Expanded Community Advisory Panel (XCAP) Meeting

Noise and Vibration Comparative Analysis Update

7.15.2020

Noise Report Updates

Increase Train Speeds

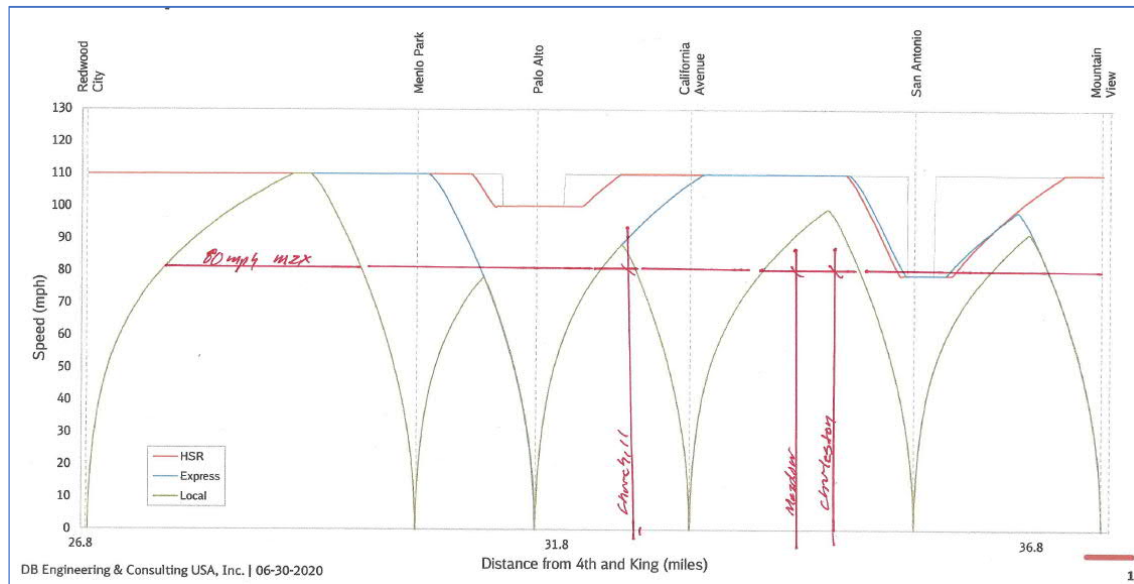
- Replace future “Electric Locomotives” with new EMU units.
- Reassess Passenger Train Speeds in accordance with Caltrain projected speed profiles.
- Increase daily total and peak hour train events to 114 trains/day, and 16 trains/peak hour (per Caltrain Electrification Study).
- Consider use of 6-foot parapet noise barriers on Closure and Underpass alternatives.
- Provide table showing relative noise reduction for each alternative.
- Revise or remove combined summary table.

Based upon Caltrain-provided future speed profiles, speeds for future EMU trains near existing grade-crossings was determined to be at or near the 80 mph limit, so this speed was used for future passenger rail operations for all predictions (freight speeds remain at 50 mph).

Revise or remove combined summary table.

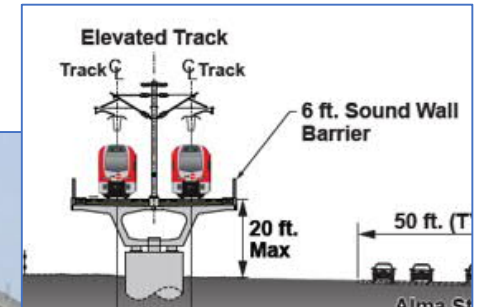
- XCAP requested to revise the summary table to either provide more technical justification for the methodology used in combining results for operational noise, operational vibration, and construction noise and vibration assessments, or remove table entirely.
- After some reconsideration, it was determined by the report's author that any attempt to combine the various assessments was ultimately a subjective decision based upon the author's opinion of which of these various assessments was more or less important, and that different opinions on relative importance could influence the results.
- Therefore, it was decided to remove this attempt to consolidate the assessment results and leave the exercise to XCAP.
